MIL-S-19500/430A
AMENDMENT 1
21 March 1994

SEMICONDUCTOR DEVICE, DUAL FIELD EFFECT TRANSISTORS, N-CHANNEL, SILICON
TYPES 2N5545, 2N5546, AND 2N5547, JAN, JANTX, AND JANTXV

FIGURE 1. Physical dimensions (TO-71)."

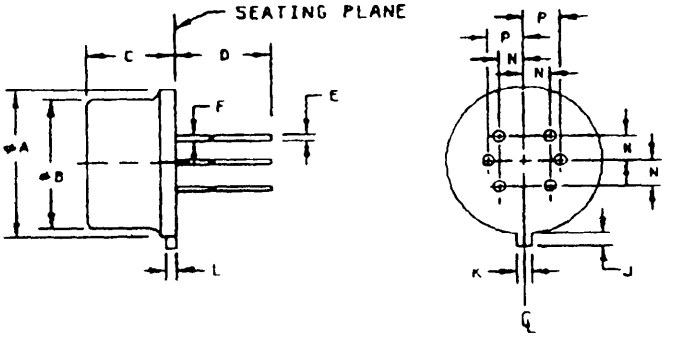
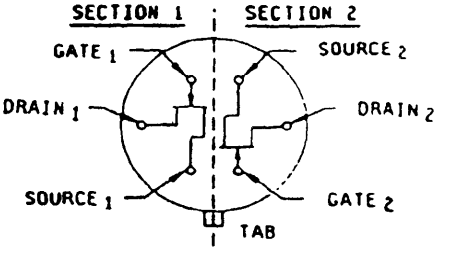
Figure 1, delete in its' entirety and substitute as follows:

Ltr	Dimensions				Notes
	Inches		Millimeters		
	Min	Max	Min	Max	
ϕA	.209	.230	5.31	5.84	
ϕB	.178	.195	4.52	4.95	
C	.170	.210	4.32	5.33	
D	.500	.750	12.70	19.05	
E		.021		.53	3
F	.016	.019	.41	.48	4
J	.028	.048	.71	1.22	7
K	.036	.046	0.91	1.17	
L		.020		.51	
N	.0354 Nom.		.90 Nom.		5
P	.0146 Nom.		.037 Nom.		5

NOTES:
1. Dimensions are in inches.
2. Metric equivalents are given for general information only.
3. Measured in the zone beyond .250 inch (6.35 mm) from the seating plane.
4. Measured in the zone from .50 inch (1.27 mm) to .250 inch (6.35 mm) from the seating plane.
5. When measured in a gauging plane .054 +.001, -.000 inch (1.37 -0.03, -0.00 mm) below the seating plane of the transistor, maximum diameter leads shall be within .007 inch (0.18 mm) of their true location relative to a maximum width tab. Smaller diameter leads shall fall within the outline of the maximum diameter lead tolerance.
6. All leads electrically insulated from case and each section electrically isolated from the other.
7. Measured from the maximum diameter of the actual device.
